AS-BUILT DRAWINGS HAVE BEEN
MODIFIED PER CONTRACTOR
MARKINGS REQUIRED ON

MIZZOU NORTH - REPLACE CHILLER
COLUMBIA, BOONE COUNTY, MISSOURI 65203

ELECTRICAL DEMOLITION PLAN

E101

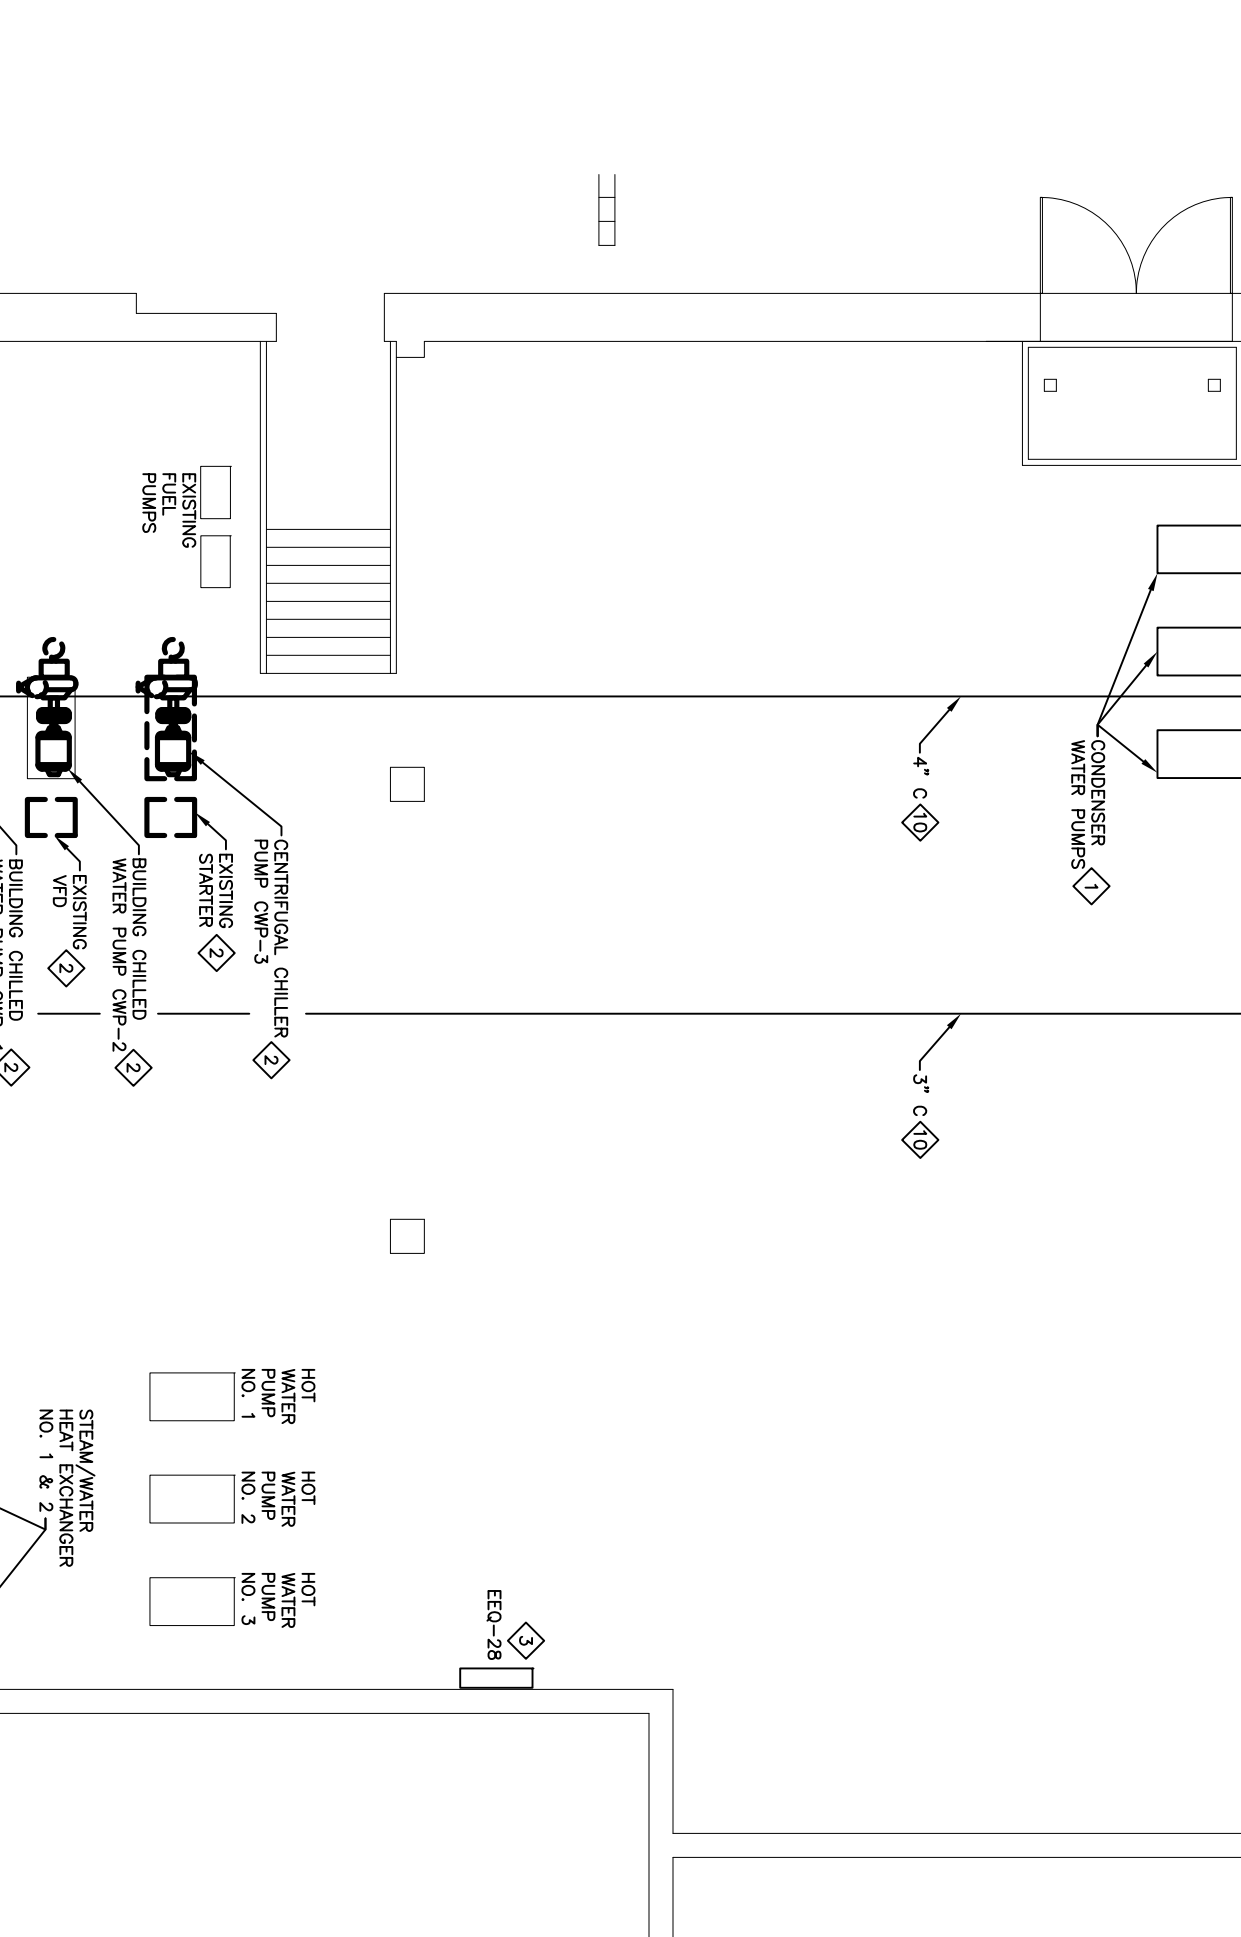
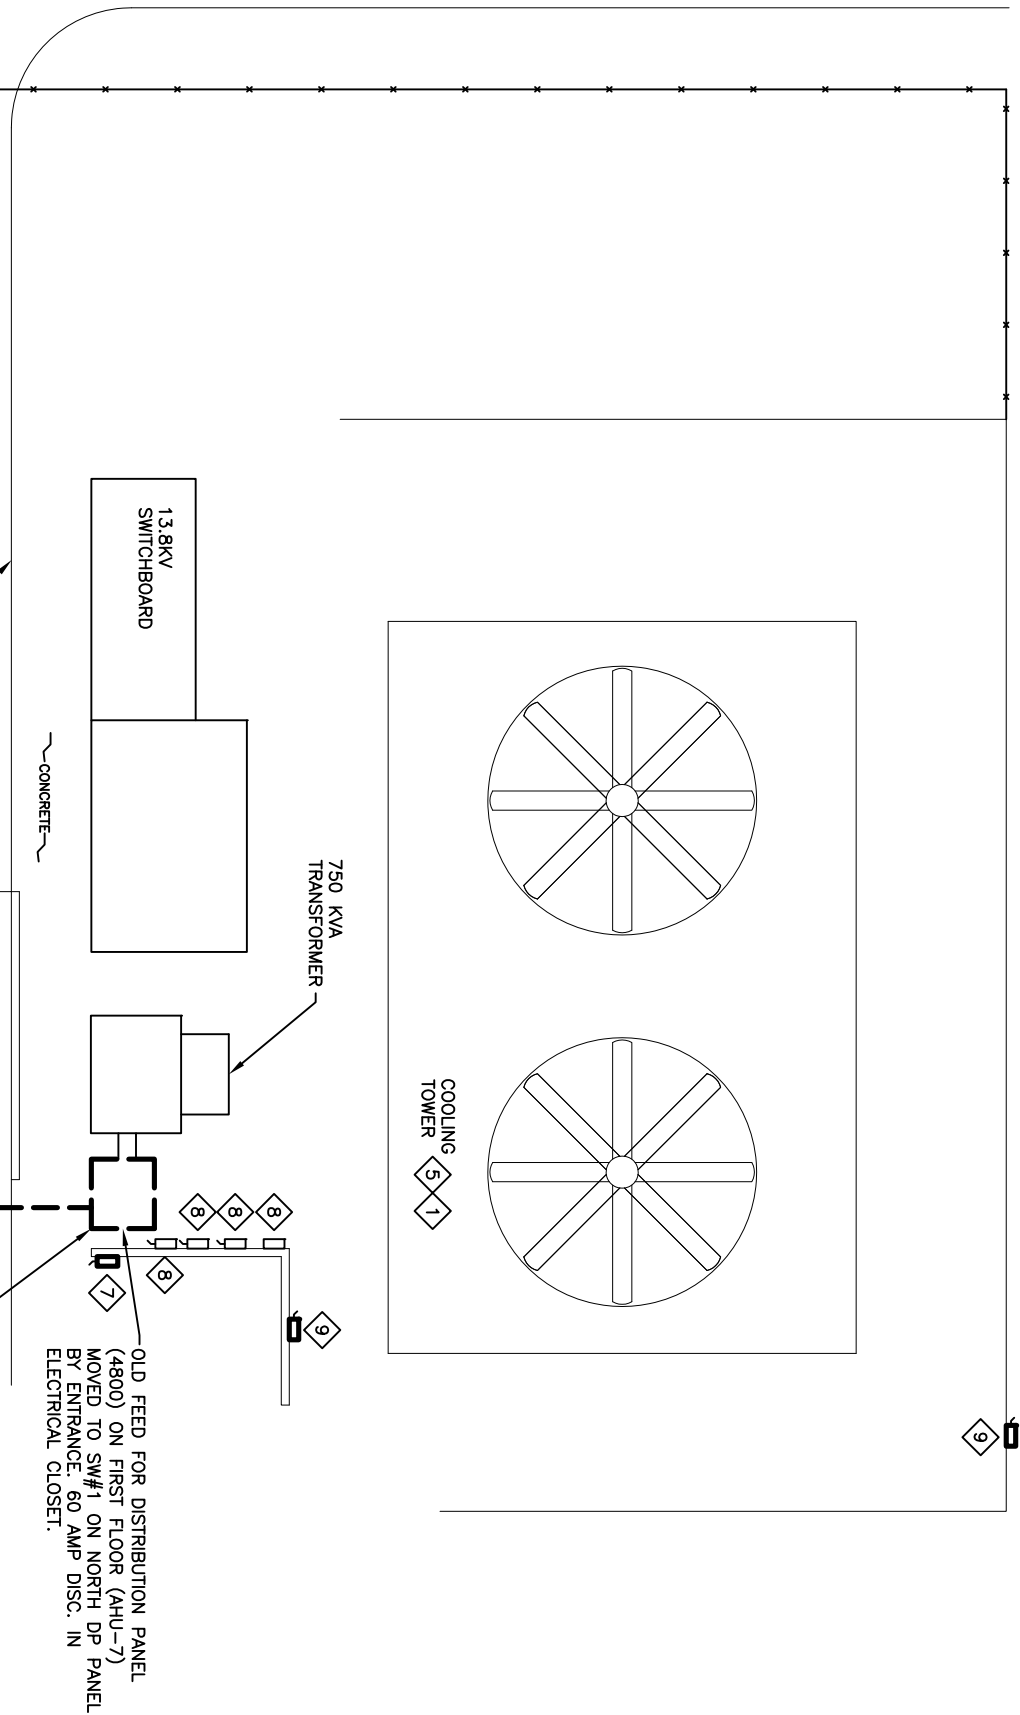
6 UNDER ALTERNATE #2 EQUIPMENT TO BE REMOVED. DEMOLISH

EQUIPMENT BACK TO 480V PULL BOX. COORDINATE FOR POSSIBLE RE-USE OF CONDUIT

7 DEMO 60A SWITCH AND FLEX CONDUIT

8 SWITCHES, FLEX CONDUIT AND 3.0 KVA TRANSFORMER TO REMAIN.

9 DEMO 200A SWITCH AND FLEX CONDUIT

10 EITHER EXISTING CHILLER FEED CONDUIT (BUT NOT BOTH) AVAILABLE FOR RE-USE TO FEED NEW PUMP. #1 FLEX CONDUIT USED TO RUN NEW PUMP. REMAINING NEW CONDUITS MUST MATCH ROUTE OF EXISTING CONDUIT TO RUN IN PARALLEL.
